**LEGAL ADVERTISEMENT
PORTLAND PLANNING BOARD MEETING**

- i. **Tabled on 10/12/16 to 10/25/16.** Level III Site Plan; 7 Unit Residential Building; 30 Merrill Street; Banner Properties, LLC., Applicant. (7:00 – 8:00 p.m. estimated time). The Board will hold a public hearing on a proposal for a new seven-unit residential building. The existing two family building will be replaced with a four story 6,580 sq. ft. building with 7 condominiums. Parking for 6 vehicles is proposed behind the building. The site is in the R-6 zone.

AGENDA PORTLAND PLANNING BOARD MEETING

- i. **Tabled on 10/12/16 to 10/25/16. Level III Site Plan; 7 Unit Residential Building; 30 Merrill Street; Banner Properties, LLC., Applicant.** (7:00 – 8:00 p.m. – estimated time) The Board will hold a public hearing on a proposal for a new seven-unit residential building. The existing two family building will be replaced with a four story 6,580 sq. ft. building with 7 condominiums. Parking for 6 vehicles is proposed behind the building. The site is in the R-6 zone.

Figure 1: Proposed changes in design, 30 Merrill Street, with 10/12 design at left, and 10/19 revised design at right

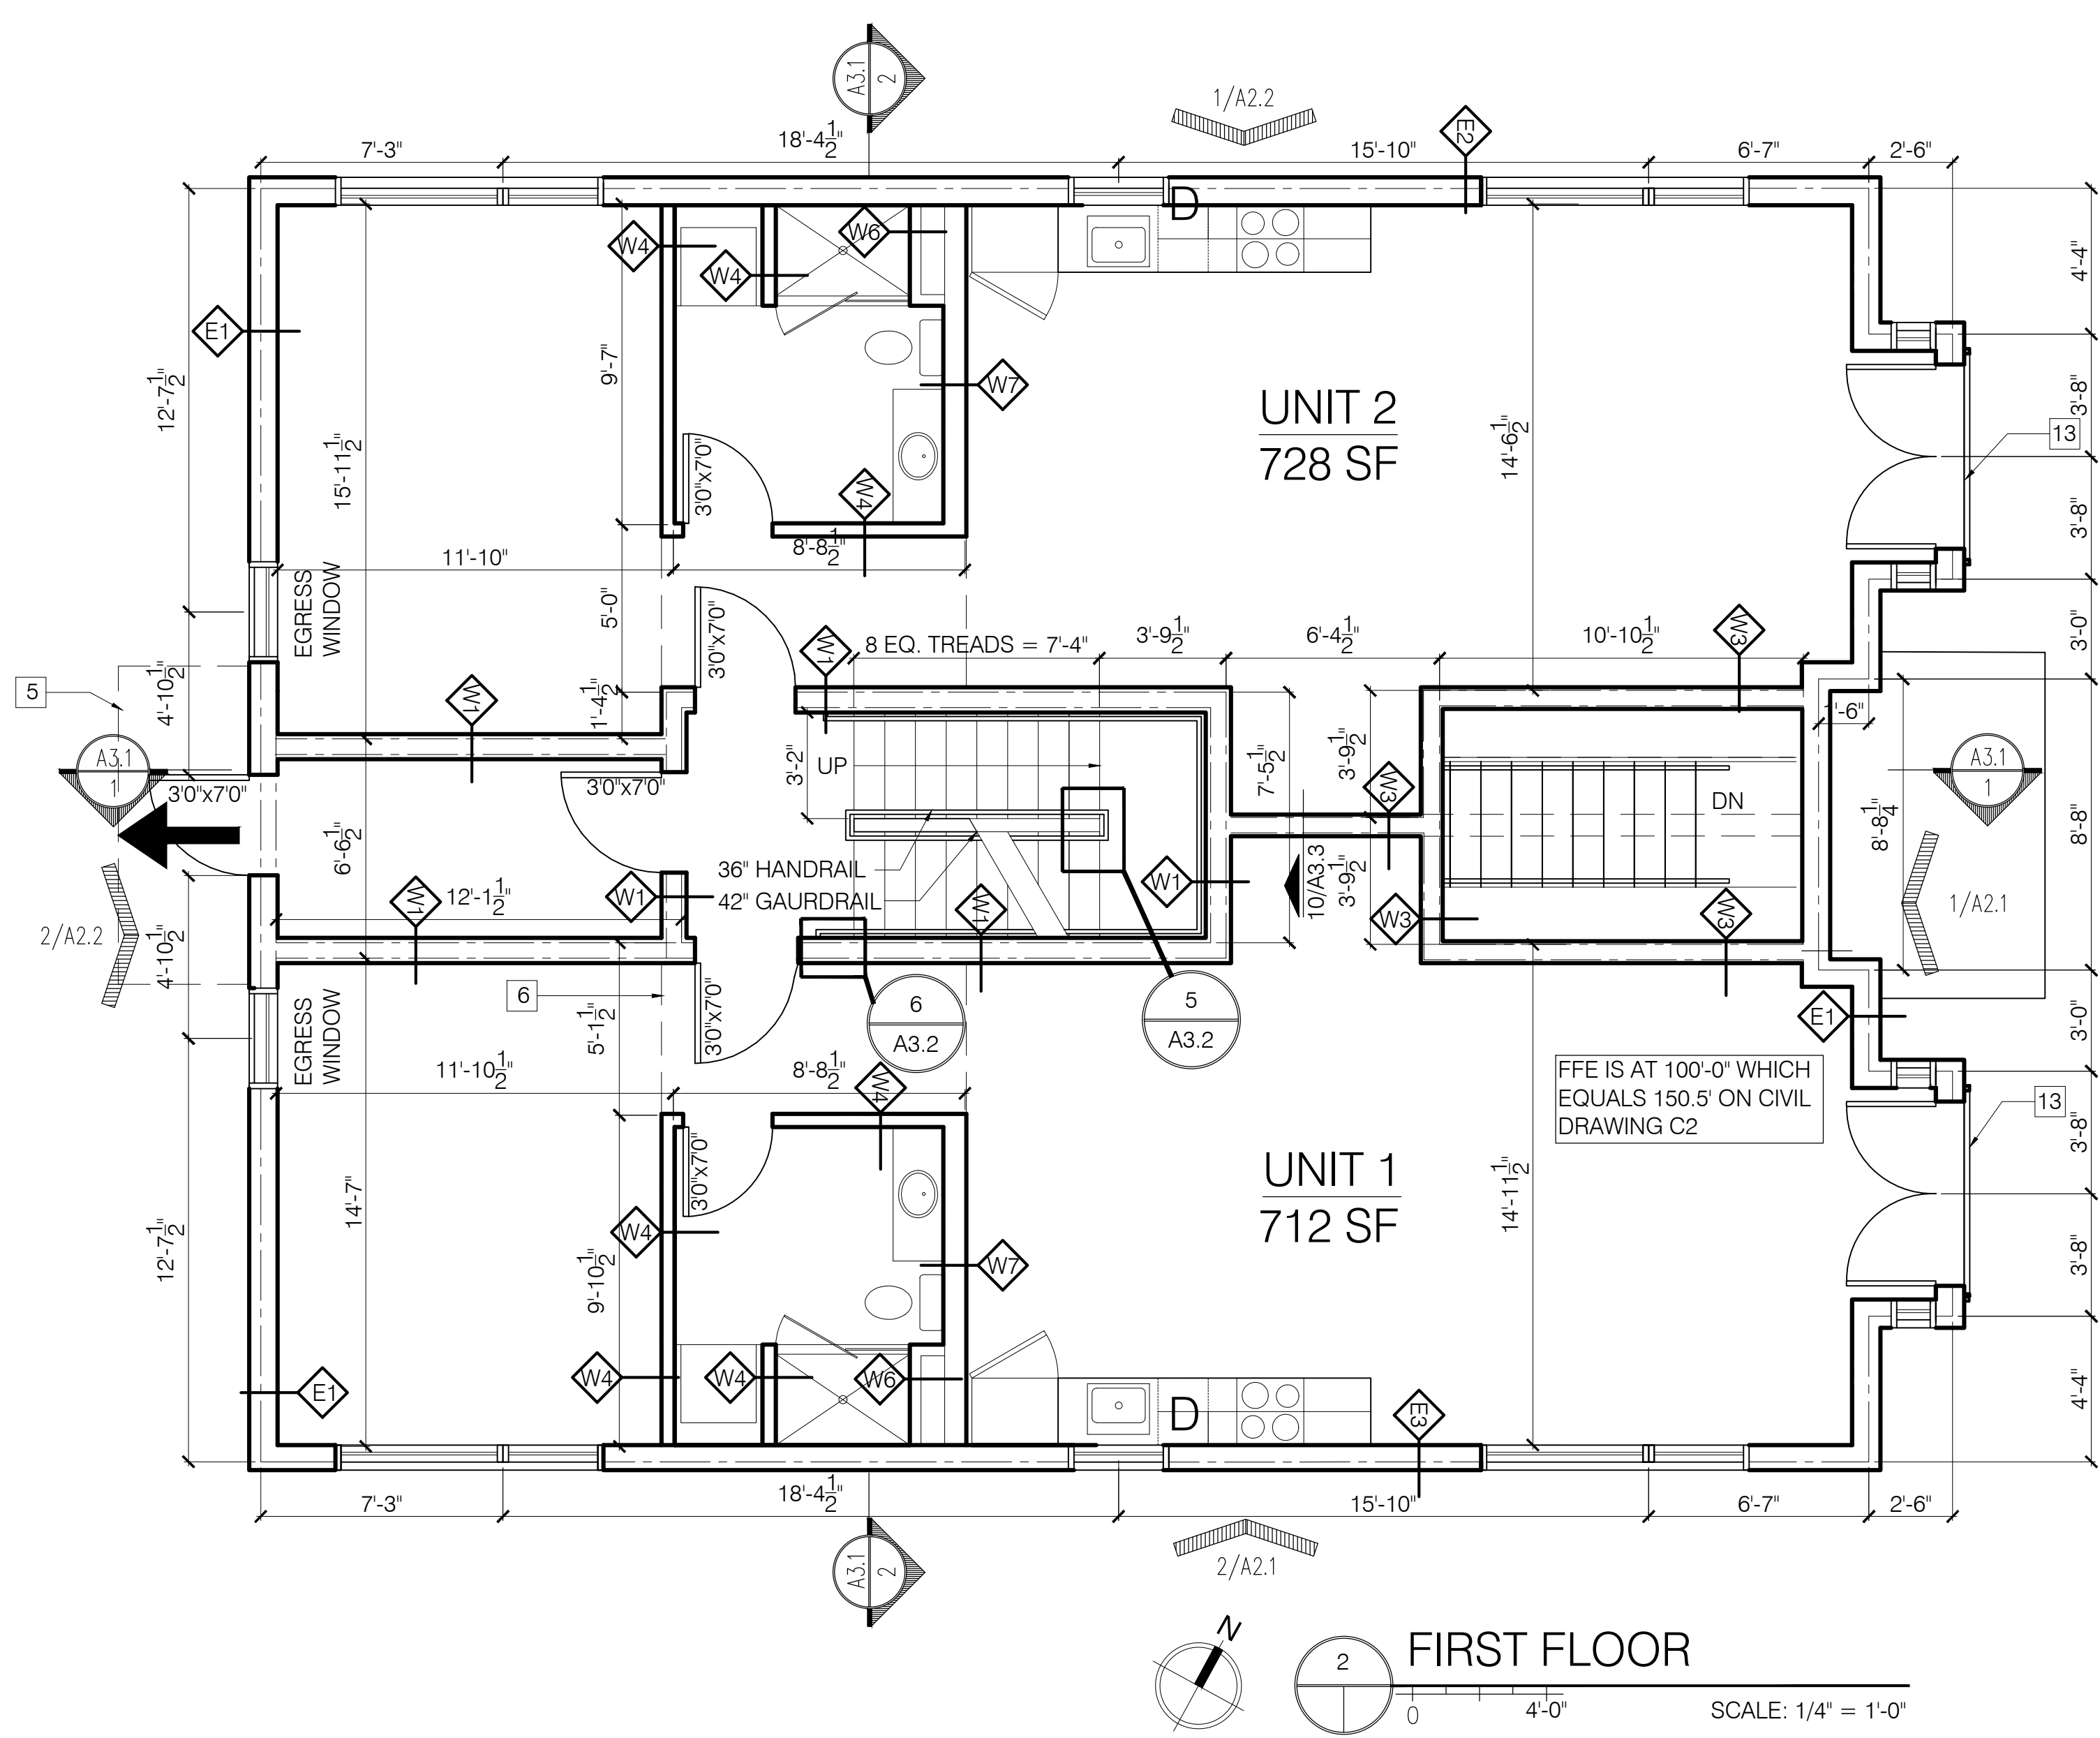
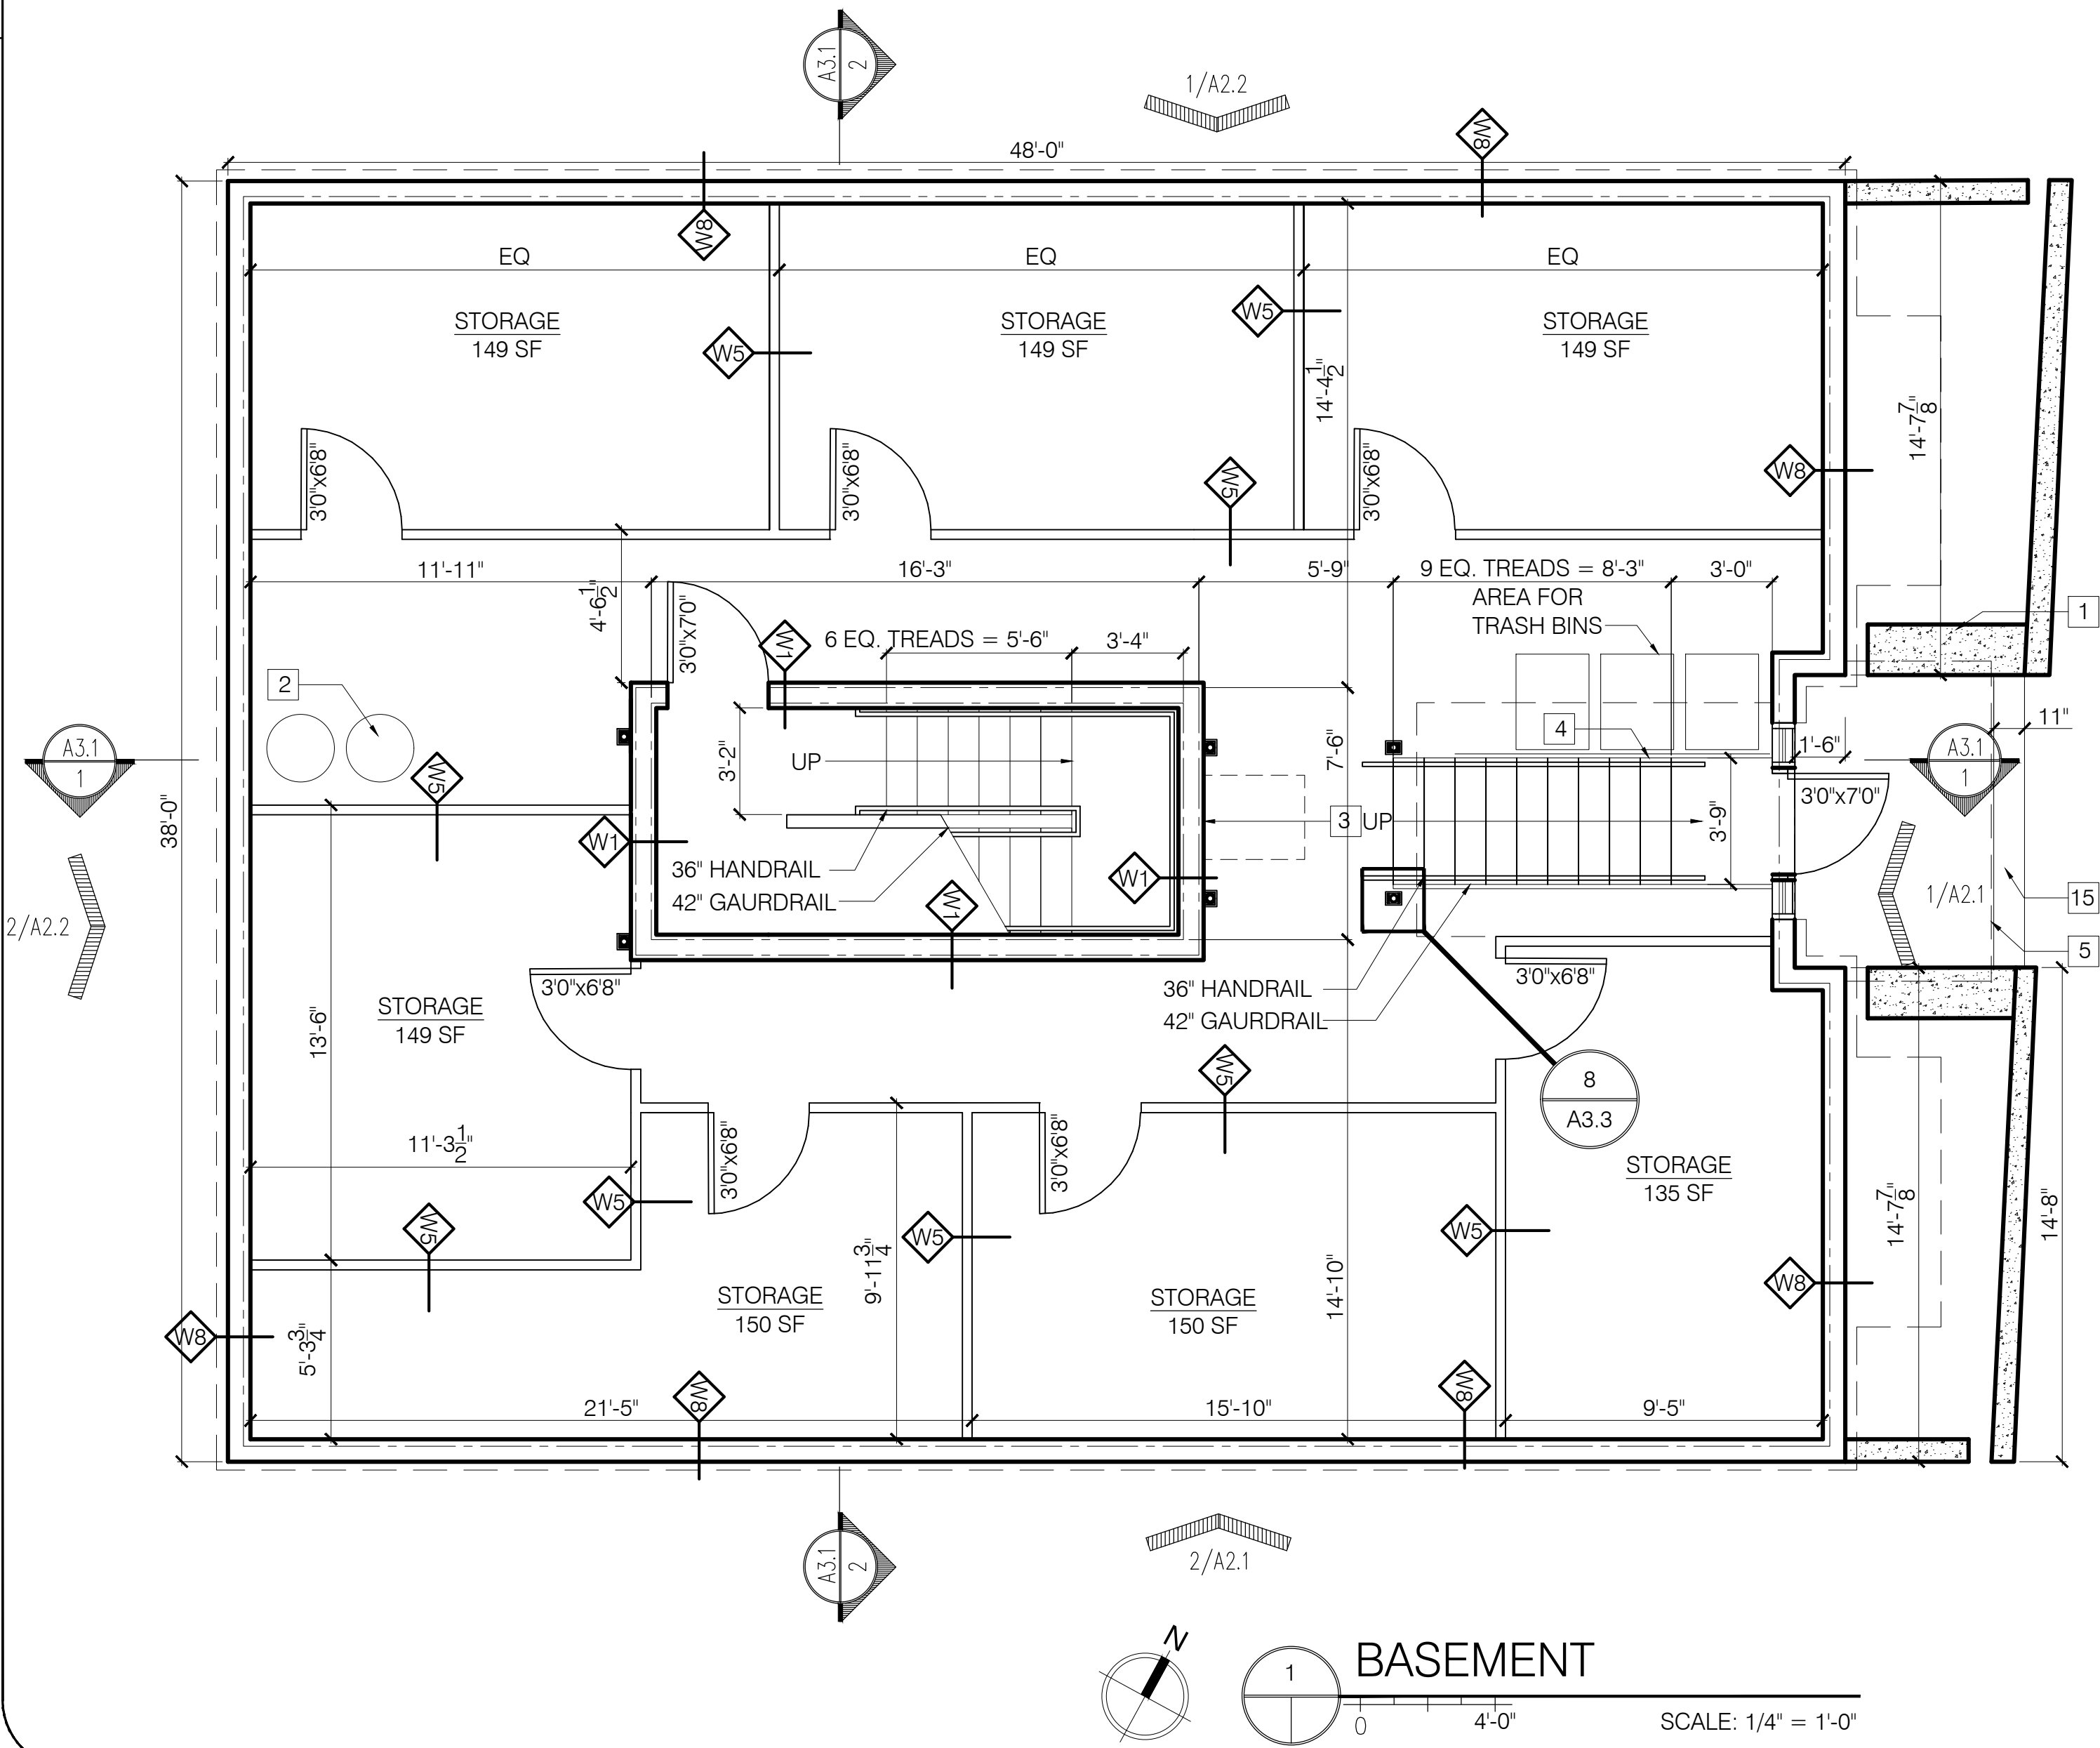
Project is more like a triple decker than it previously was.
